SERVICE BULLETIN NO: 1005

FUSELAGE - GENERAL CONTROL COLUMN SUPPORT ON FRAME 2 - INSPECTION

B4-PC 11

Support Frame 2 - Inspection
Figure 1

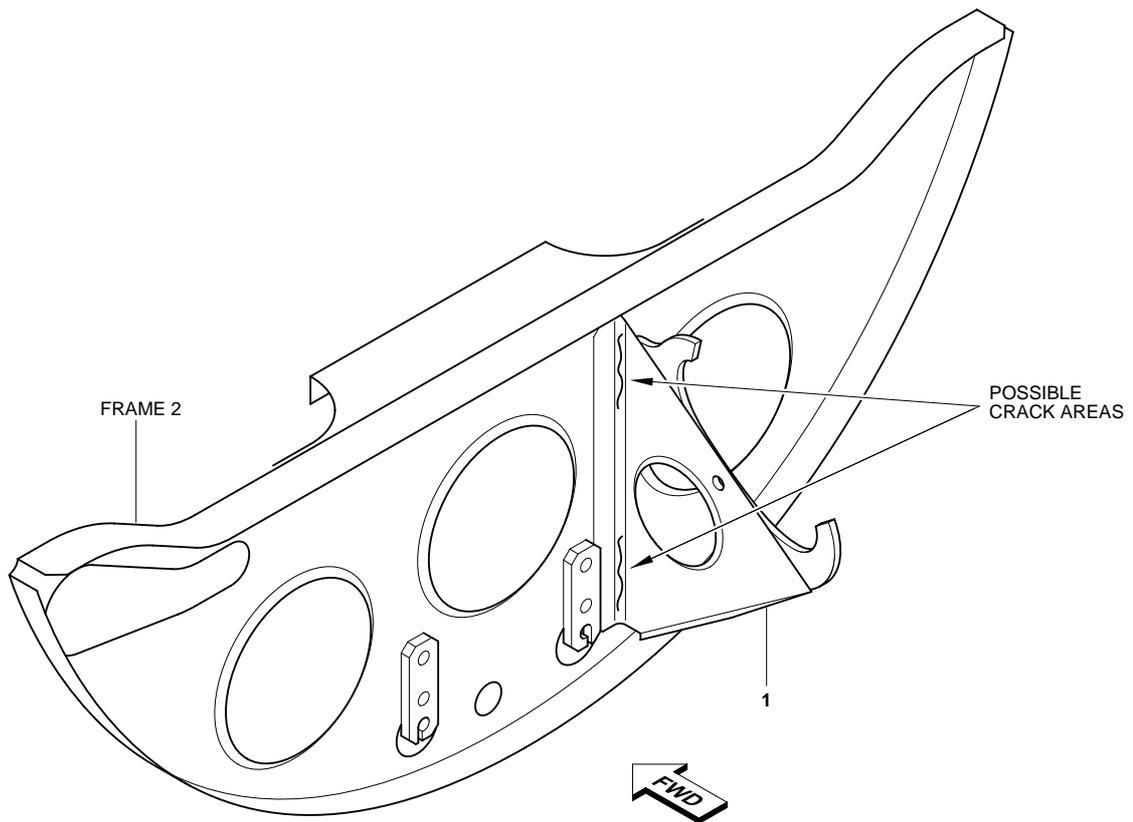
B. Inspection of the Support (Ref. Fig. 1)

- (1) Use a source of bright light and X10 magnifier and examine support (1) for cracks. Do this specially in the areas of the upper and lower bend angles where the support (1) is attached to Frame 2.
- (2) Cracks are not permitted in the support (1). Replace the support (1) if you find cracks.
